Access Compliance Report

Public Rights-of-Way

| Intersection ID: 10033470 | Main Street: OLD_PINEVILLE_RD | Cross Street: N/A | Location: SW |
| ADA ID: 8B17A4B73648 | Ramp Type: Directional1 | Initial Pass/Fail: Pass | Overall Compliance: No |

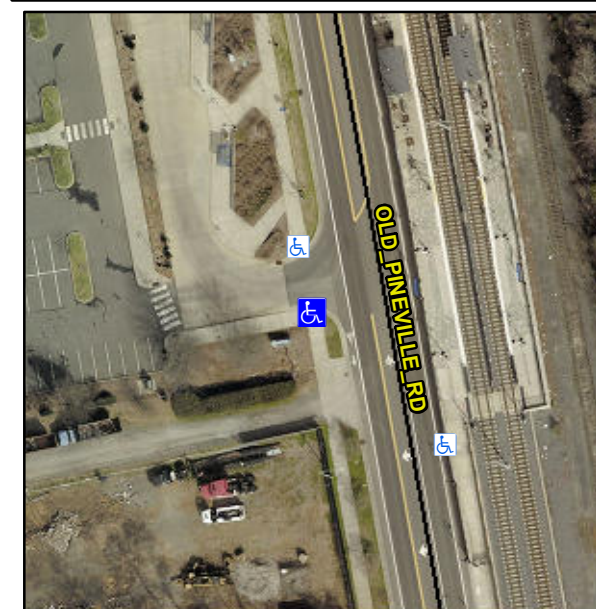
**R304.5.3, R304.2.3, R305.1.4, R305.2,
R304.5.4**

| Compliance | Description | Data | Compliance | Description | Data |
|------------|-----------------------|-------|------------|-----------------------------|------|
| No | Landing X Slope (%) | 2.6 | No | DWS Full Width? | No |
| N/A | Landing Curb? (Y/N) | No | No | DWS Offset LT (in) | 3.0 |
| Yes | Gutter Ponding? | No | No | Gutter Slope (%) | 6.5 |
| Yes | Gutter Lip Ht (in) | 0.0 | No | Gutter X Slope (%) | 2.2 |

**Remove & Replace Entire Ramp.
Remove & Replace Gutter.**
